Product Change Notice (PCN)

PCN Number: PCN-0374437R-01

Product(s) Affected: CS-3603, CS-3606, CS-3612 & CS-3624

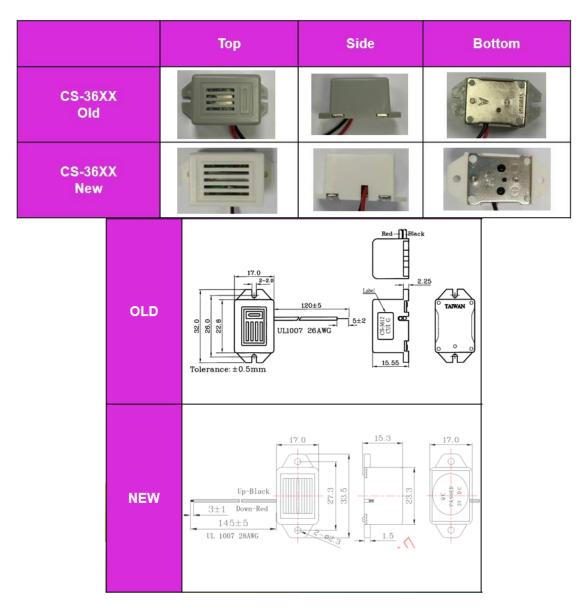
Description of Change: Current consumption has decreased by 10mA on CS-3603 & CS-3606, it has increased by 5mA on CS-3612 & increased by 11mA on CS-3624. Operating voltage on CS-3624 has a new minimum of 18VDC. SPL has been increased by 3dB on CS-3603, CS-3606 & CS-3612. SPL has been increased by 2dB on CS-3624. Operating temperature on all four models has been widened to -30~70°C. Storage temperature on all four models has been shifted to -35~75°C. Some dimensional changes & elongated sound holes (shown in drawing below).
